AGENDA - LPP

**REPORT TO GEORGES RIVER COUNCIL
LPP MEETING OF THURSDAY, 19 SEPTEMBER 2019**

LPP Report No	LPP035-19	Development Application No	DA2017/0584
Site Address & Ward Locality	61-63 Lawrence Street, Peakhurst Peakhurst Ward		
Proposed Development	Lot consolidation, demolition of the existing structures and construction of three (3) storey residential flat building with basement parking.		
Owners	Younan Management Pty Ltd, CHY Holdings Pty Ltd, Maria A. Rasic		
Applicant	Cornerstone Design		
Planner/Architect	Cornerstone Design		
Date Of Lodgement	24/11/2017		
Submissions	Nil Submissions		
Cost of Works	\$3,390,000.00		
Local Planning Panel Criteria	Development is defined as a “Residential Flat Building” and is subject to SEPP 65. A Clause 4.6 variation in respect to exceedance of the height control		
List of all relevant s.4.15 matters (formerly s79C(1)(a))	State Environmental Planning Policy No 55 - Remediation of Land, State Environmental Planning Policy No 65 - Design Quality of Residential Apartment Development, State Environmental Planning Policy (Vegetation in Non-Rural Areas) 2017, State Environmental Planning Policy – Infrastructure, Draft Environmental State Envi

Figure 5: Western elevation of the building illustrating area of non-compliance with the height control in red (Source: Planning Ingenuity, 2018)

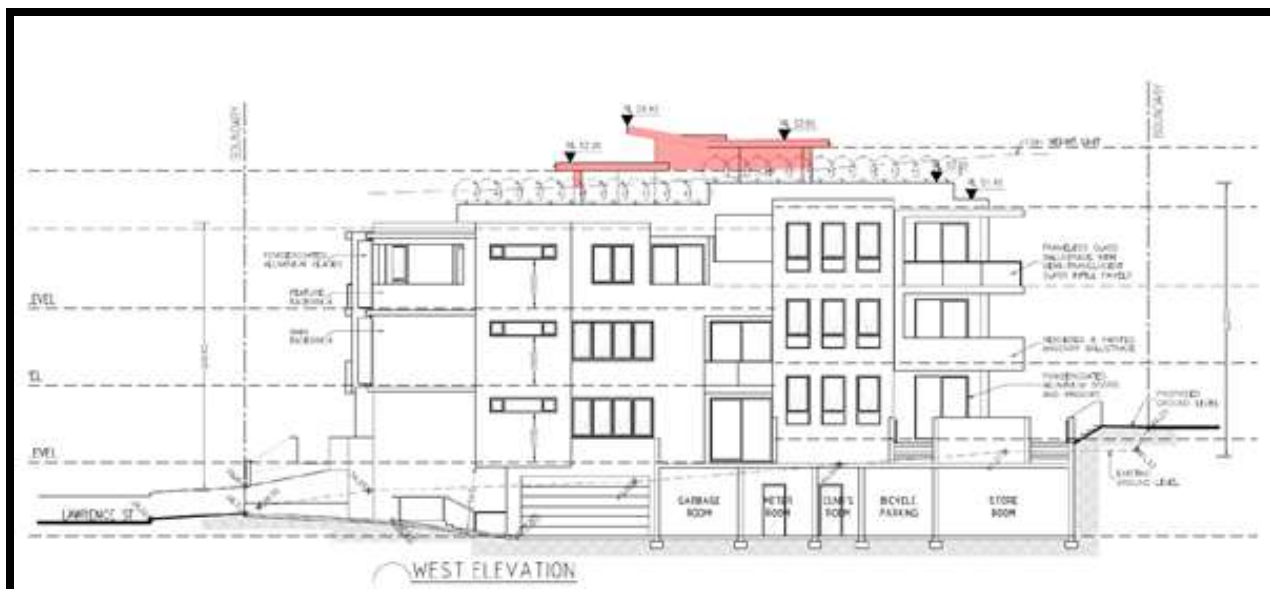
The proposed development seeks a variation to the development standard relating to height. Hurstville Local Environmental Plan 2012 identifies a maximum height of 12m. The proposed development will have a maximum height of 13.85m.

A variation to the height can be considered under Clause 4.6 – Exceptions to Development Standards in the Hurstville Local Environmental Plan. In assessing the variation, the provisions identified in Clause 4.6 have to be considered. The applicant's town planning consultant, Planning Principles has provided a response which is detailed and considered below.

Figure 6: 'Figure 13' from the submitted Statement of Environmental Effects (SEE) Eastern Elevation (Source: Planning Ingenuity, 2018)

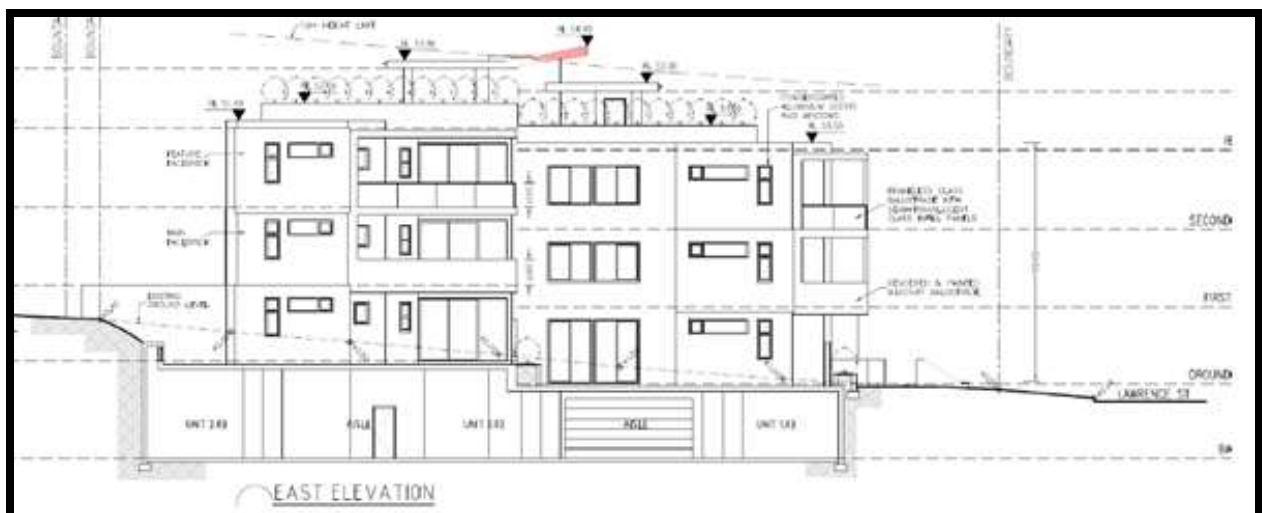
“As indicated in the eastern elevation, all residential floor space a significant amount of the building is located below the maximum height limit and the projecting elements are limited to the lift overrun and shading structure where the site falls away to the street frontage. In addition, the building is fully compliant with the height requirements at the street frontage to Lawrence Street”.

Officer Comment - The applicant's justification is supported. As identified in red, the extent of the height variation relates to the lift overrun and vergola which is centrally located within the building footprint. The proposed variation does not comprise of floor space or area which could be readily converted into floor space.

Figure 7: 'Figure 14' from the submitted Statement of Environmental Effects (SEE) Western Elevation (Source: Planning Ingenuity, 2018)

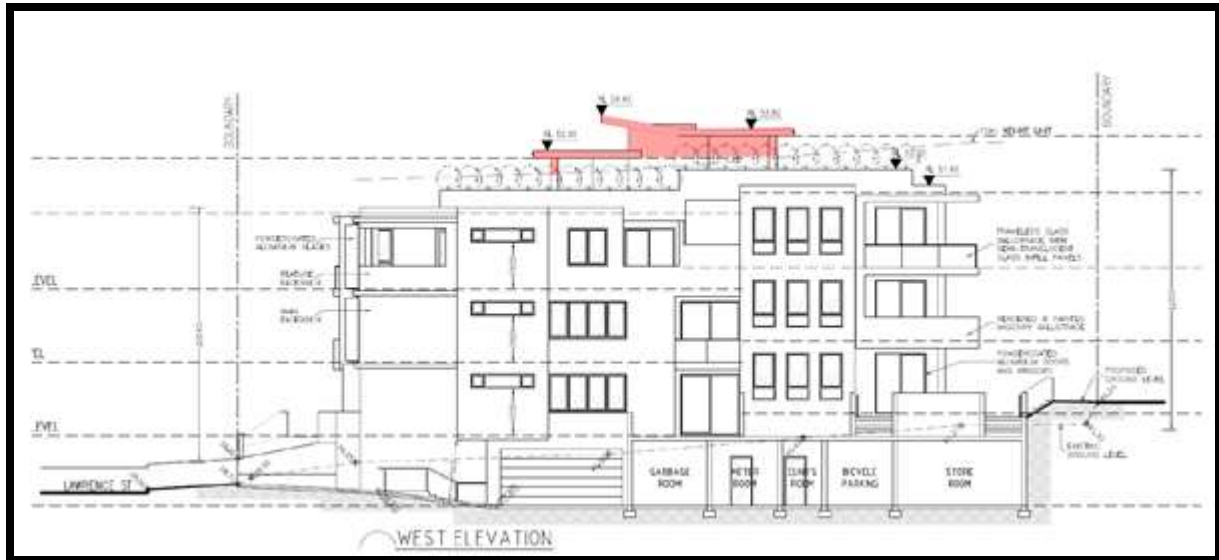
“As indicated in Figure 14 the height non-compliance is limited to the centre of the building where access to the roof top terrace is achieved via lift and stair access and the shade structure is provided. The maximum extent of non-compliance is 1.85m above the 12m height plane, representing a variation of 15.4% of the standard”.
